City of Portland, Maine - Building or Use Permit Application 389 Congress Street, 04101, Tel: (207) 874-8703, FAX: 874-8716

Location of Construction: Dunbar St 101 Burlington Ave		Owner: KTO Builders		Phone: 892-2058		Permit No: 990330	
Owner Address: 13 Varney Mill Rd Windham, ME 04062		Lessee/Buyer's Name:		Phone:		Business Name:	
Contractor Name: SAA		Address:		Phone:		Permit Issued: APR 14 1999	
Past Use: Vacant Land		Proposed Use: Single Family Dwelling		COST OF WORK: \$ 65,000.00		PERMIT FEE: \$ 345.00	
				FIRE DEPT. <input type="checkbox"/> Approved <input type="checkbox"/> Denied		INSPECTION: Use Group A3 Type 5B BOC-96	
Proposed Project Description: Construct Single Family dwelling w/2 car garage				Signature:		Signature: <i>[Signature]</i>	
				PEDESTRIAN ACTIVITIES DISTRICT (P.A.D.)		Zoning Approval: Special Zone or Reviews: <input type="checkbox"/> Shoreland <input type="checkbox"/> Wetland <input type="checkbox"/> Flood Zone <input type="checkbox"/> Subdivision <input type="checkbox"/> Site Plan maj <input type="checkbox"/> minor <input type="checkbox"/> mm <input type="checkbox"/>

RE: Certificate of Occupancy
102 Huntington Avenue (410-G-001)

**CITY OF PORTLAND, M

Actual
 Plot Plan
 410-F-7

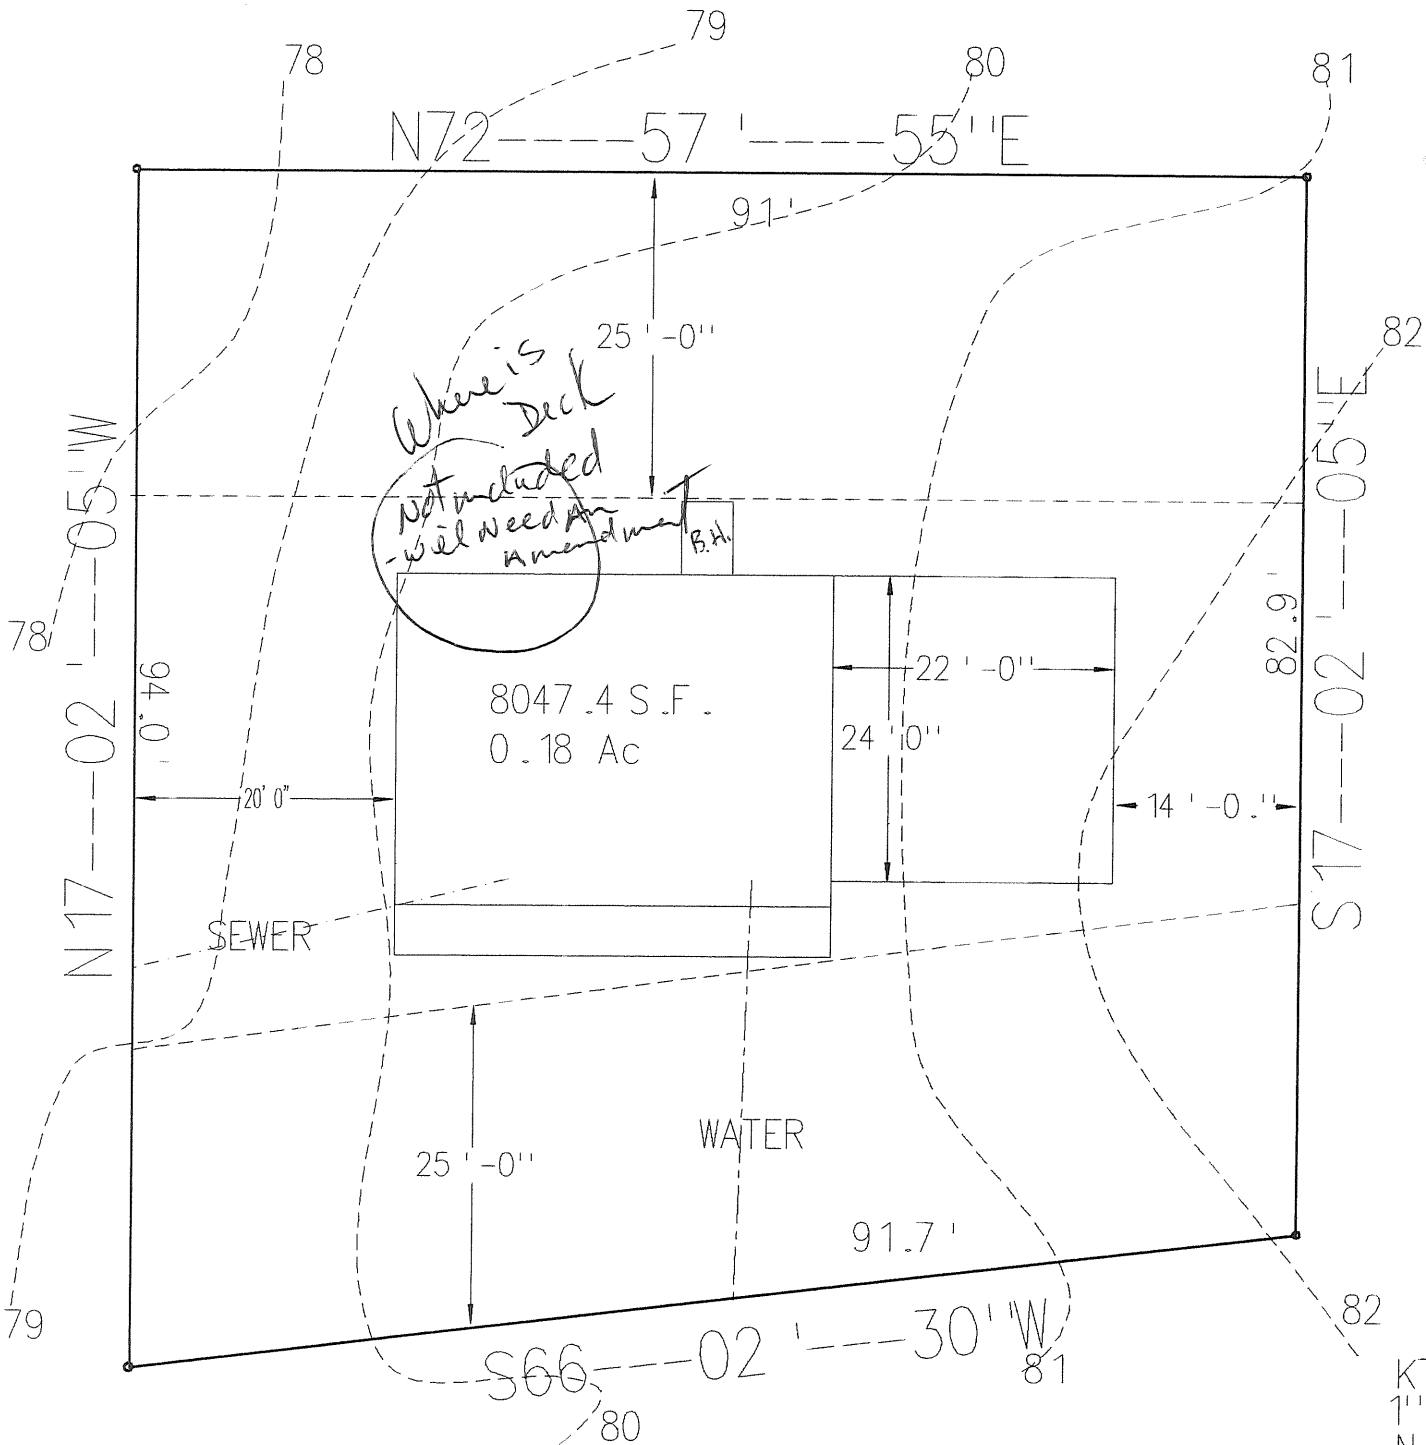
Lot Street Frontage - 50' req. - 91' shown

Front Yard - 25' req. - 25' shown

Rear Yard - 25' req. - 25' shown

Side Yard - 20' req on side st (on left) - 20' shown
14' req on other side (right) - 14' shown

Projections - front porch - rear bulk head - deck is implied, but not shown - This will need to be an Amendment.

This permit IS NOT including this rear deck. You will need to file an amendment to include that deck. We will need a complete plot plan showing the location, size, and setback of this deck. We will also need structural plans showing sizes of the materials being used.
